CRIME IMPACT STATEMENT

BIGNOR STREET PARK, BIGNOR STREET, CHEETHAM HILL, MANCHESTER
PRIMARY SCHOOL (2,073sqm) & CRICKET NETS FOR COMMUNITY USE

VERSION A: 06/02/2023

REFERENCE: 2022/0630/CIS/01

1 Visual Audit

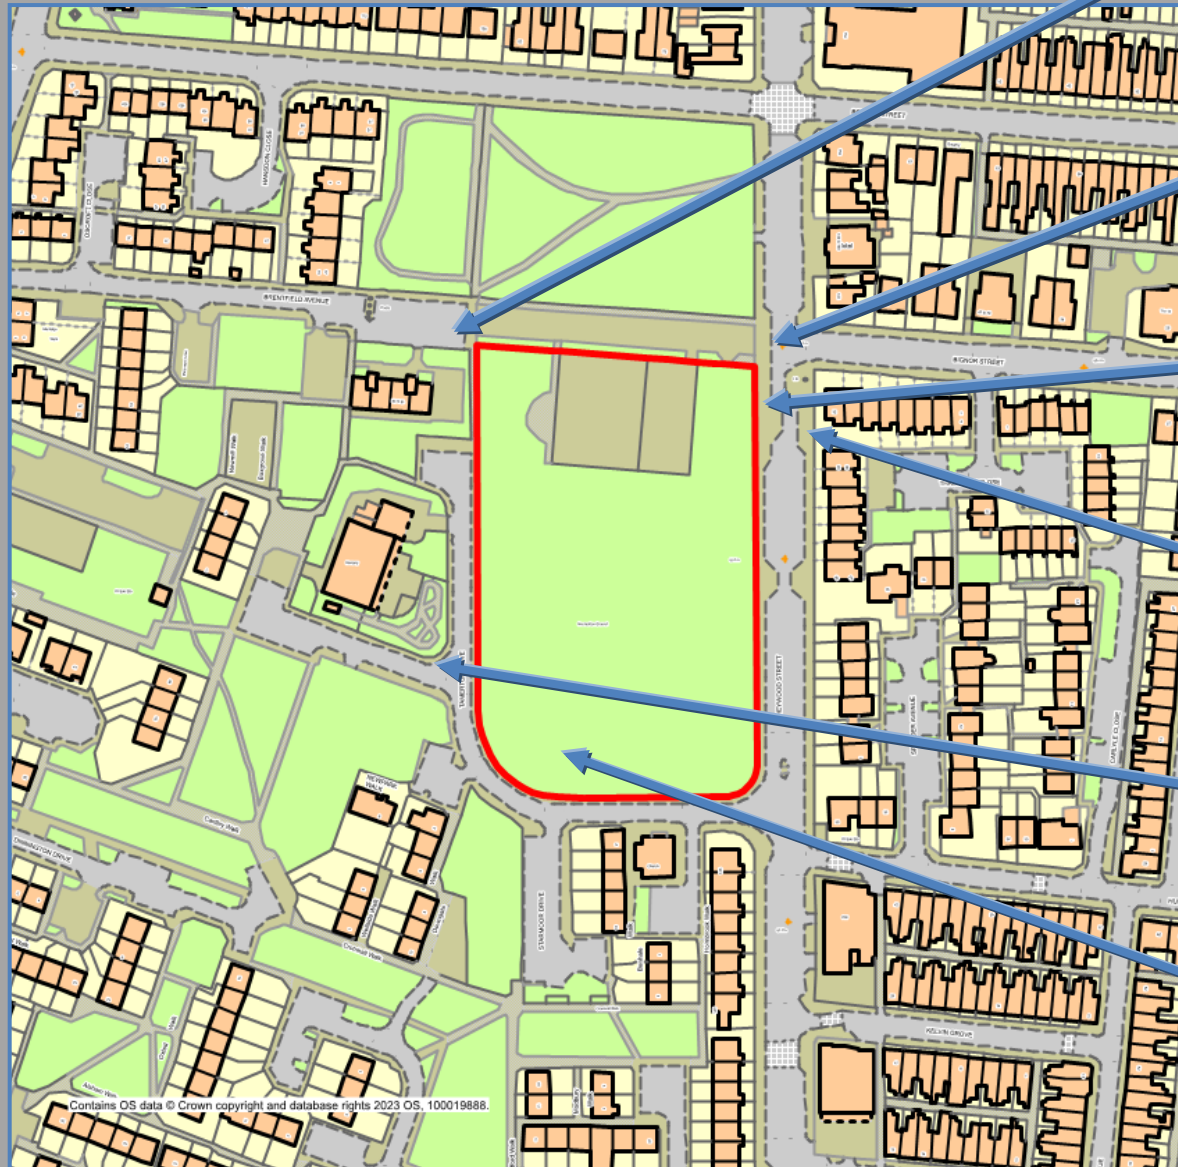
It is currently formed by a public park (Bignor Street Park), which comprises of a hard surface basketball court to the north, open grassland to the south and some mature trees to the perimeter. The park is currently enclosed with weld-mesh fencing, which has been vandalised in places and panels have been removed to create alternative access points. There is evidence of unauthorised vehicular access within the site.

To the south-west and south of the site is a church and Radburn style residential estates featuring pedestrian routes separated from vehicular movement (often to the rear of dwellings), communal areas of landscaping and communal parking areas remote from the dwellings they serve. This type of layout can result in a lack of definition between public and private space, creating areas which can attract nuisance, anti-social behaviour and criminal damage. The networks of the pedestrian access routes through such estates often make them extremely permeable and also provide easy access/escape routes for criminals to utilise – particularly those which benefit from little/no natural surveillance and are likely to be infrequently used.

The residential properties on the opposite side of Heywood Street back onto the route itself (with high walls/fencing enclosing their rear boundaries) – meaning the site benefits from limited levels of direct overlooking.
